# Access Compliance Report

## Public Rights-of-Way

Intersection ID: 10142	Main Street: TUCKASEEGEE_RD	Cross Street: TODDVILLE_RD	Location: S
ADA ID: 5A8B7D7331DF	Ramp Type: Perp	Initial Pass/Fail: Fail	Overall Compliance: No
Codes/Mitigation Info/Possible Solution		Field Measurements/Component Compliance	
Severity Score: 13.75

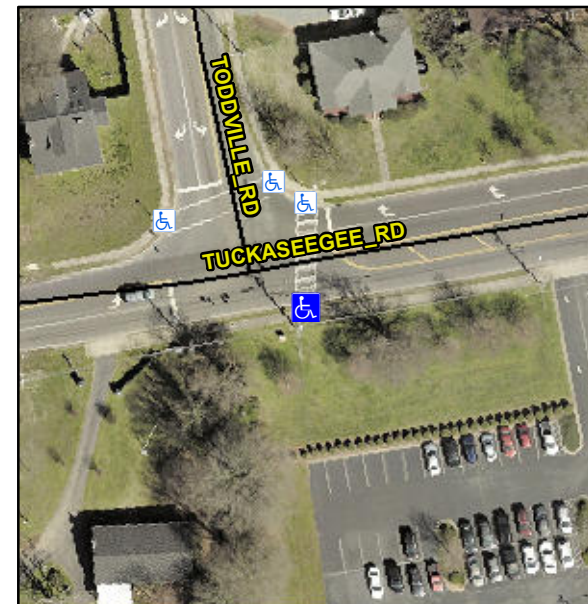
**R304.2.2, R304.5.3**

Compliance	Description	Data	Compliance	Description	Data
N/A	Ramp Length (in)	85.0	No	Ramp Slope (%)	9.8
Yes	Ramp Width (in)	62.0	No	Ramp XSlope (%)	2.7
N/A	Flare Type LT	N/A	N/A	Flare Type RT	N/A
N/A	Flare Slope LT (%)	N/A	N/A	Flare Slope RT (%)	N/A
N/A	Flare Traversable LT?	N/A	N/A	Flare Traversable RT?	N/A
N/A	Landing Length (in)	N/A	N/A	DWS Provided?	N/A
N/A	Landing Width (in)	N/A	N/A	DWS Contrast?	N/A
N/A	Landing Slope (%)	N/A	N/A	DWS Length (in)	N/A
N/A	Landing X Slope (%)	N/A	N/A	DWS Full Width?	N/A
N/A	Landing Curb? (Y/N)	N/A	N/A	DWS Offset (in)	N/A
N/A	Shared Landing?	N/A			
N/A	Gutter Ponding?	N/A	N/A	Gutter Slope (%)	N/A
N/A	Gutter Lip Ht (in)	N/A	N/A	Gutter X Slope (%)	N/A
N/A	Painted X Walk1?	Yes	N/A	Painted X Walk2?	N/A
	X Walk 1 Direction	To N		X Walk 2 Direction	N/A
N/A	X Walk 1 Width (in)	109.0	N/A	X Walk 2 Width (in)	N/A
	X Walk 1 Slope (%)	4.6		X Walk 2 Slope (%)	N/A
	X Walk 1 X Slope (%)	0.4		X Walk 2 X Slope (%)	N/A

**Remove & Replace Entire Ramp.**
